## Product / Process Change Notification (PCN)

**PCN #:** PCN\_WCAP-ASLU\_20220121

**Affected Series:** WCAP-ASLU

**PCN Date:** January 21, 2022

Example new drawings with direct dimensioning

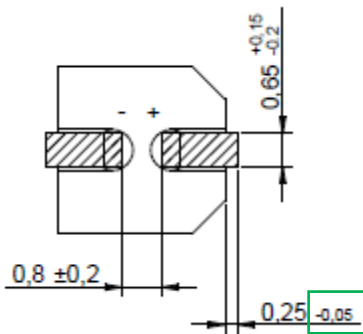
- An Example of the old and new drawings are shown below in order to visualize the corrections of the dimensions. Würth Elektronik will update the dimensioning from indirect dimensioning to direct dimensioning.

In the course of the update from indirect to direct dimensioning the values for the dimensions and tolerances will be updated. The upcoming corrections can be seen more detailed in the pictures above.

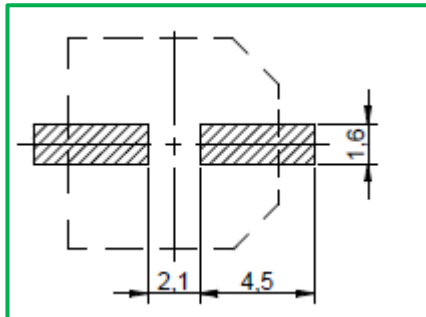
- Würth Elektronik will update the Tolerance of the following value to “- 0.05 mm“ for the following part numbers:

865090268009	865090368008	865090468010	865090468011	865090668014
865090668015	865090668016	865090768002	865090768003	865090768004
865090168010	865090768005
